SERVICE BULLETIN

FUJI HEAVY INDUSTRIES LTD.

NO. 200-003 DATE November 7, 1981 (SUPERSEDES NO. 200-003)
REV. B DATE September 18, 1991 (SUPERSEDES NO. 200-003A)
REASON To change priority, modification requirement, etc.

1. SUBJECT	: Inspection and Modification of F.STA 7105 Bulkhead and Replacement of Bracket.
2. AIRCRAFT AFFECTED	: All FA-200 aircraft
3. PRIORITY	: Mandatory

FIGURE 1. LOCATION OF F.STA 7105

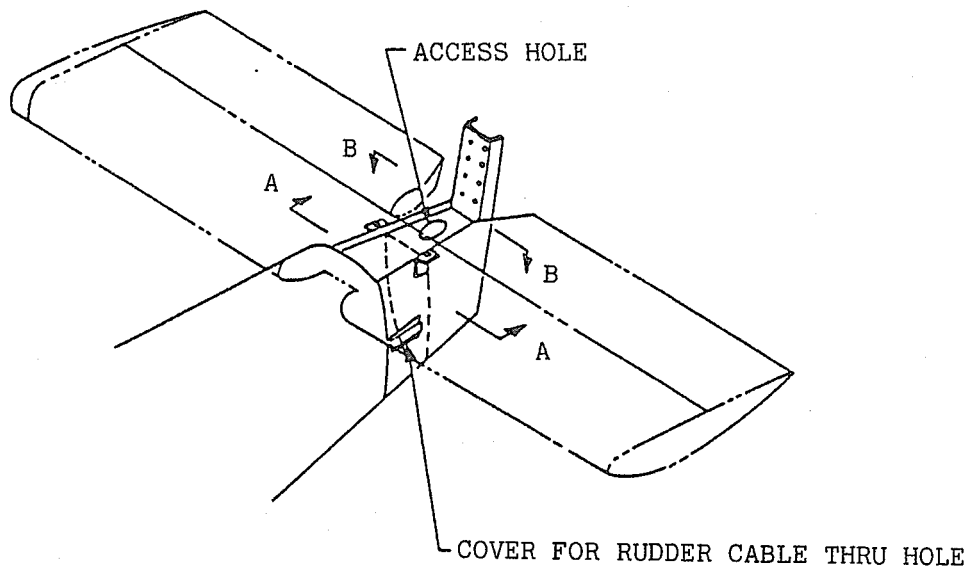
- (c) Inspect F.STA 7105 bulkhead web for cracks. (see figure 2 for crack suspected areas.) It is recommended that a small inspection mirror be used through the rudder cable thru hole (as shown in figure 1) for this inspection.
- (d) Inspect aft side (doubler) of the above bulkhead for cracks. Use a suitable mirror through access hole in the upper tail cone web.

FIGURE 2. (VIEW A-A) F.STA 7105 BULKHEAD

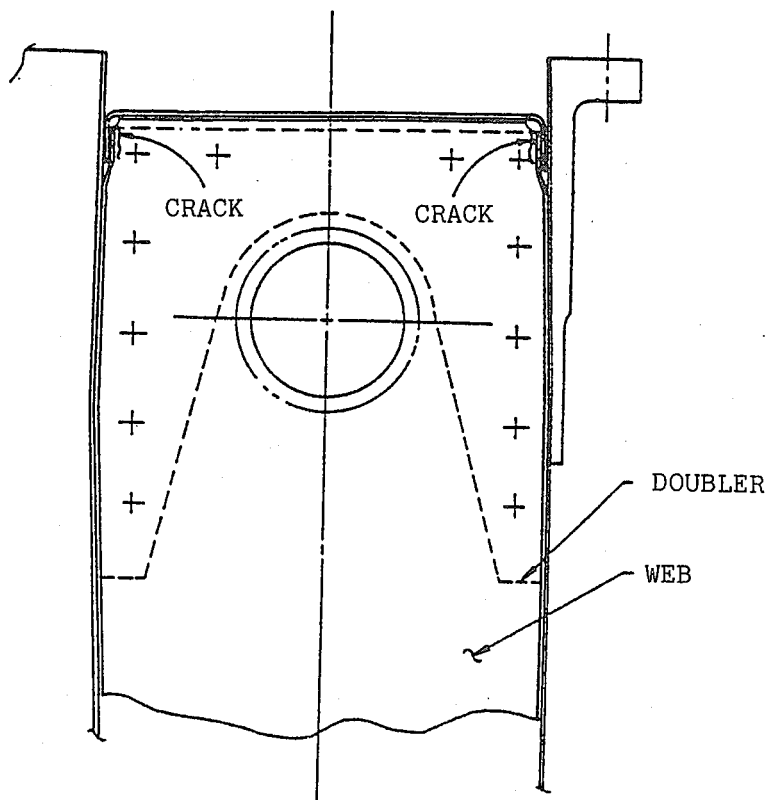
4. REASON	: (1) There have been instances reported whereby cracks have been found in the upper corners of F.STA 7105 bulkhead web and doubler. As a result of investigation, it has been determined that inspection and modification are required. (2) Since there have been instances reported whereby cracks have been found in the both left and right corners of the bracket added per SB No. 200-003, replacement of the bracket is required.

(1) Inspection of F.STA 7105 (Reference figure 2):

FIGURE 3. (VIEW B-B) DETAILS FOR MODIFICATION
FIGURE 4. DETAILS FOR STOP MODIFICATION

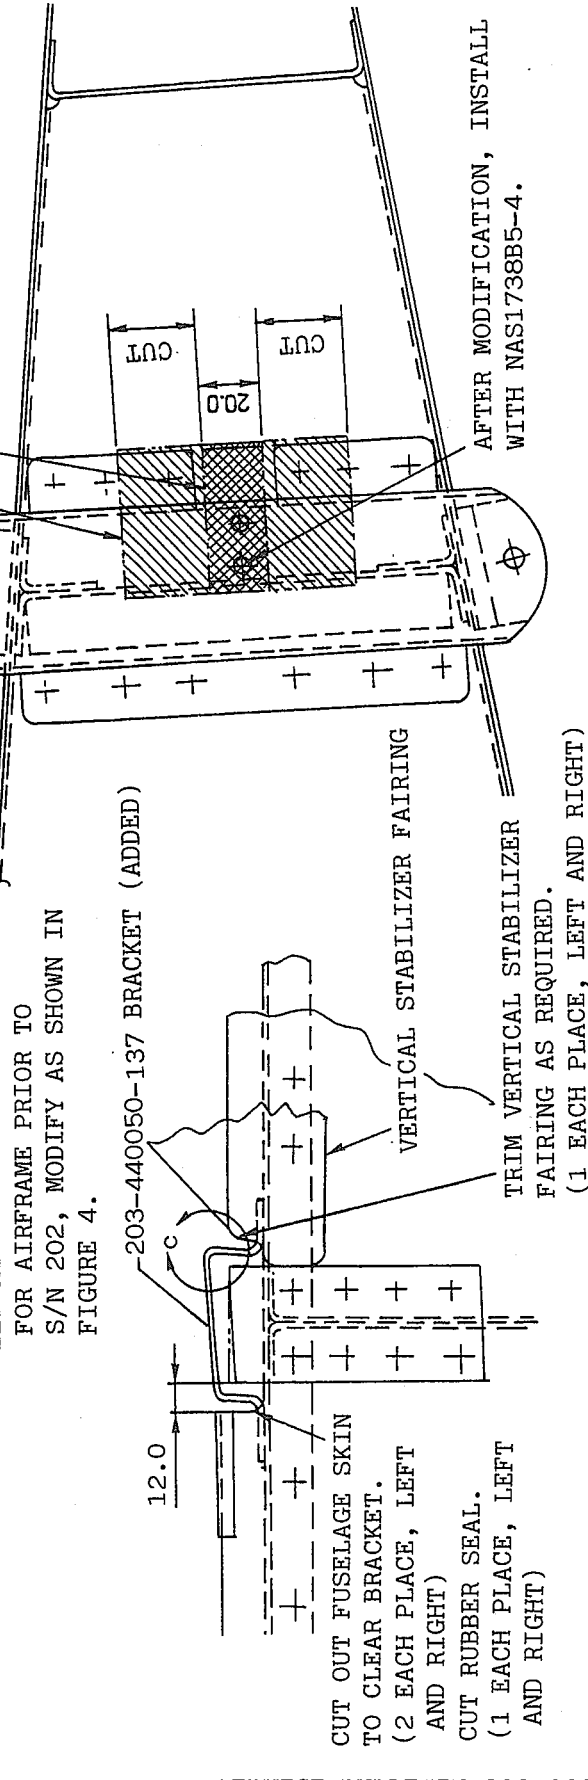
- (hA) See figure 3. Cut out fuselage skin, and add chamfer on fittings for horizontal stabilizer rear spar as shown in detail C.
(Finish chamfered surface smoothly.)

- (i) Install bracket, P/N 203-440050-137, on tail cone upper web between horizontal stabilizer rear spar fittings as shown in figure 3. Trim upper ends of fuselage skin as required.

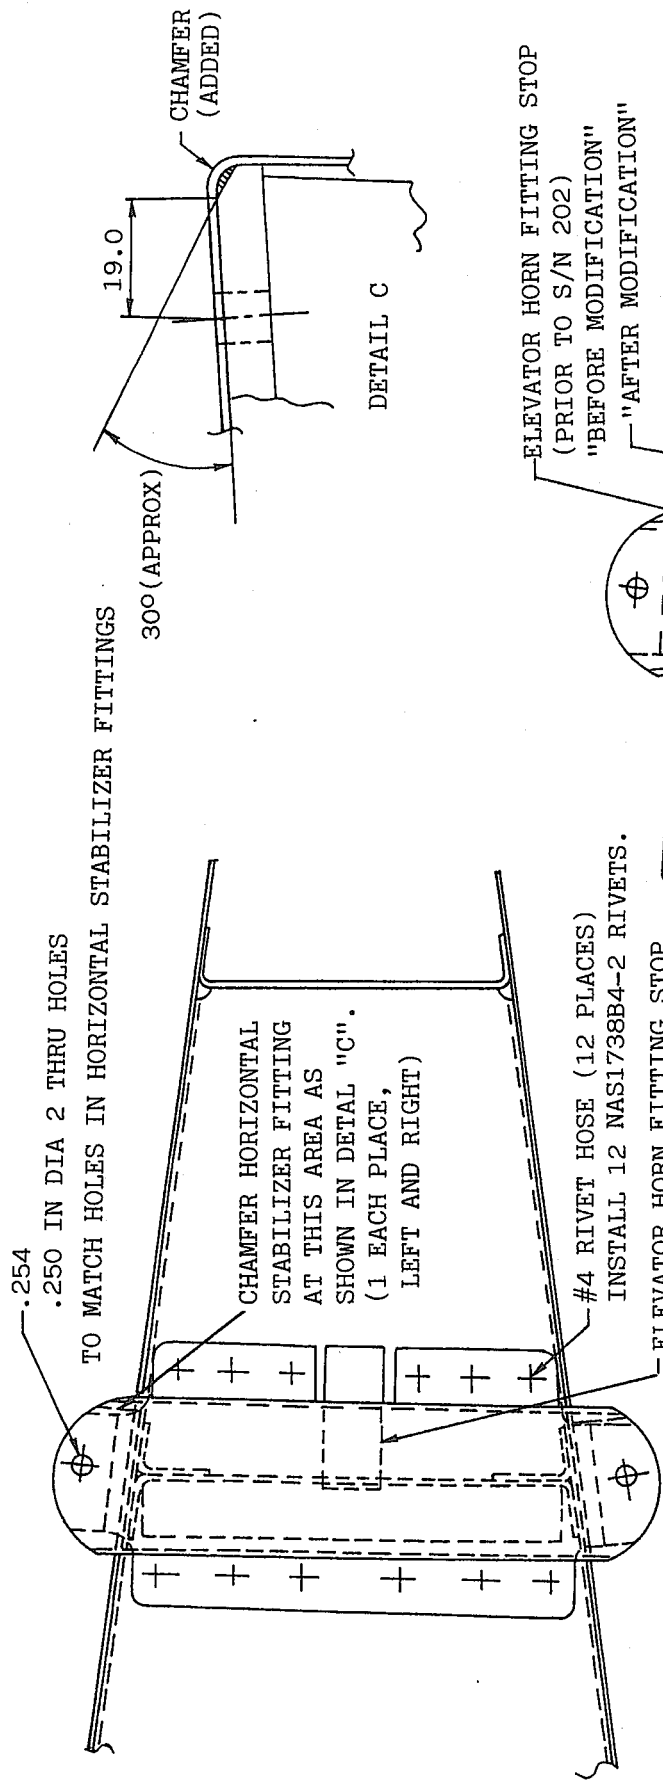
- (h) For aircraft prior to S/N 202, remove elevator horn fitting stop and modify as shown in figure 4.
(Applicable only to aircraft, prior to S/N 202, which have not had bulkhead modification per SB No. 200-003 accomplished.)

FIGURE 5 DETAIL FOR
203-440050-137 BRACKET

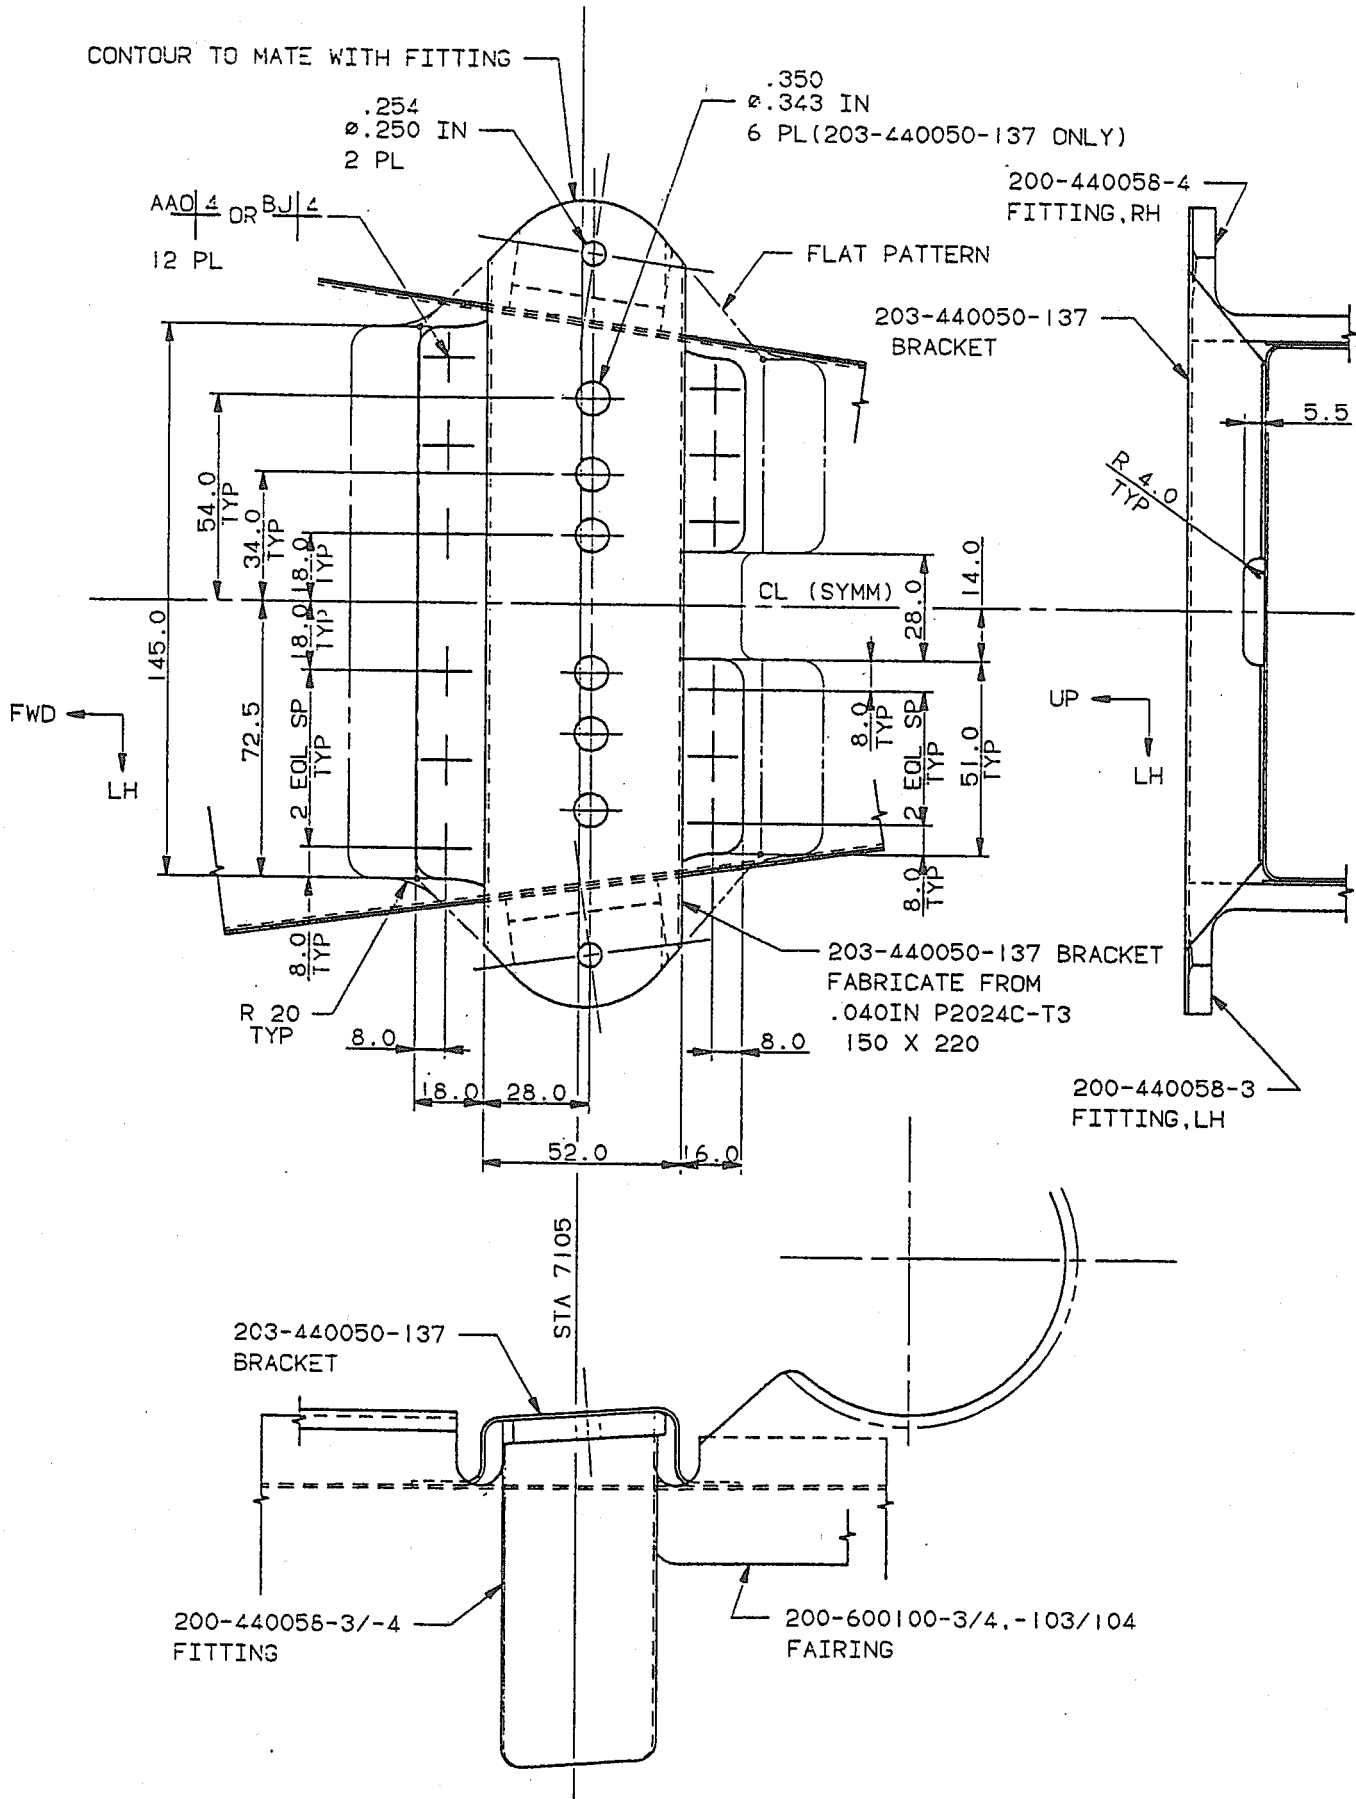
- (1) For aircraft with bracket installed, remove the existing bracket and install new bracket P/N 203-440050-137.
- (2) Locally fabricate bracket P/N 203-440050-137 in accordance with figure 5.
